Subject: Adequacy Review Response, M-2021-002

I am in receipt of your letter dated June 30, 2021 titled "Adequacy Review, 112c Construction Materials Application Strod Pit, File No. M-2021-002." Please see the attached responses to the inadequacies listed in your letter:

TEMPORARY BERM

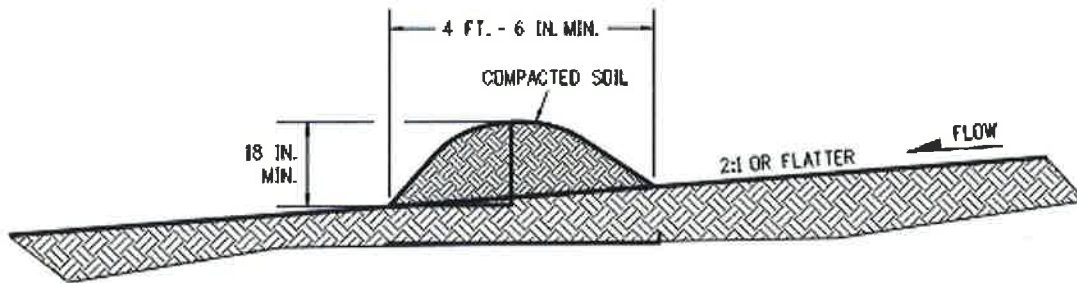
3. We will ensure that all reclaimed areas maintain positive drainage to ensure storm water is not impounded.
4. An earthen temporary berm will be used as the BMP during reclamation. Please see the detail on the following page from the CDOT M&S Standards. The berm will be removed once reclamation is complete and vegetation is established.
